SUBJECT: Forwards responses to NRC request for info re DNBR core protection calculator & proprietary & nonproprietary CEN-184(S) "Responses to Questions on Documents Supporting Songs-2 Licensing Submittal."

Subject: Docket Nos. 50-361 and 50-362
San Onofre Nuclear Generating Station
Units 2 and 3

CPC

FIGURE 1

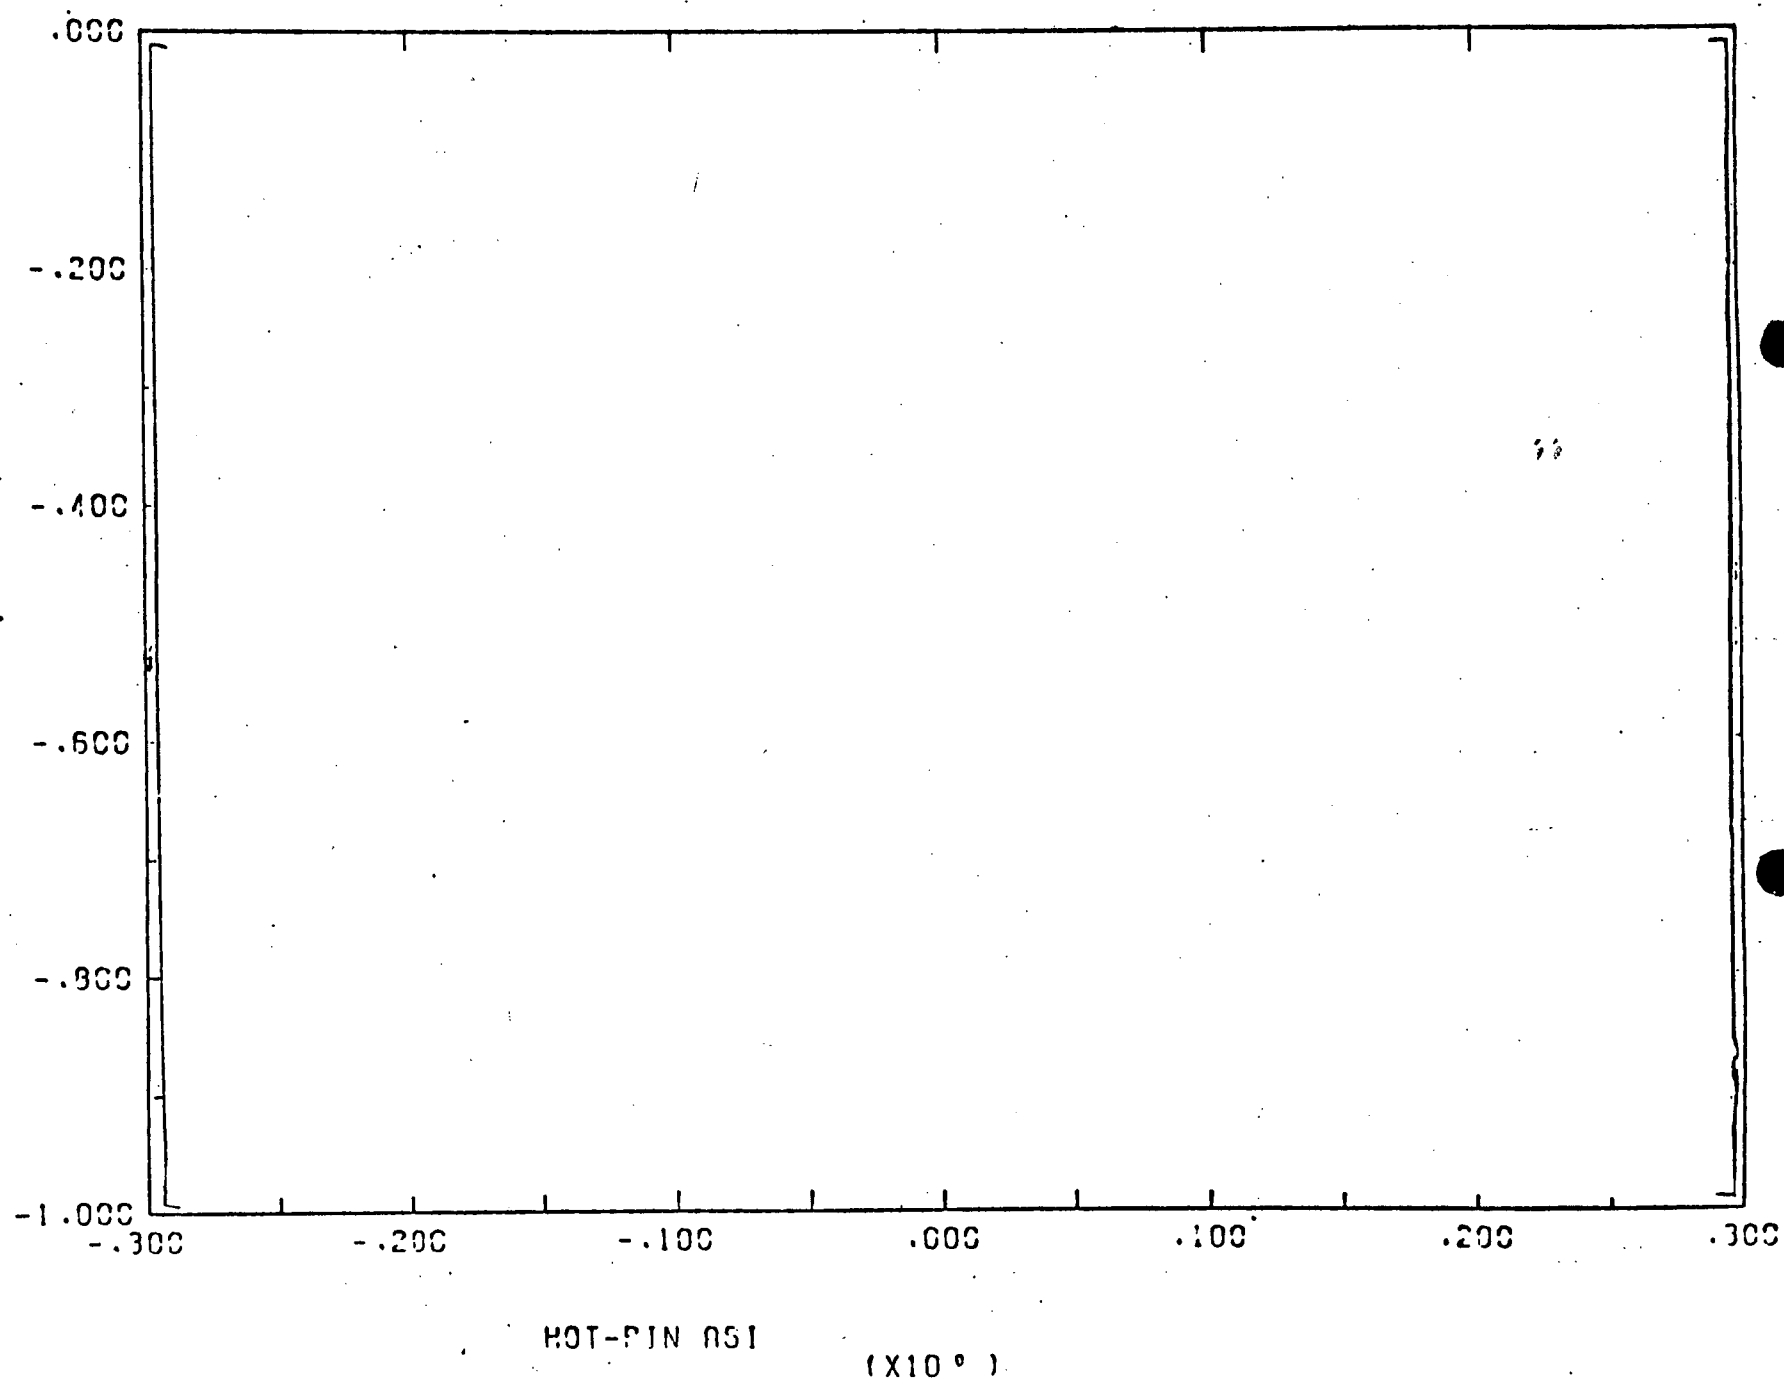
Provide a sensitivity study of DNBR vs. BERR1 for various ASI and flow conditions.

A sensitivity study of the derivative, $\frac{d \% \text{ OPM}}{d \% \text{ DNBR}}$ was performed using the CETOP-D SONGS-2 Cycle 1 model. This study examined the change in overpower margin relative to change in the DNBR limit from [] to [] for the following conditions:

A plot of $\frac{d \% \text{ OPM}}{d \% \text{ DNBR}}$ for each condition is given in Figure 1.
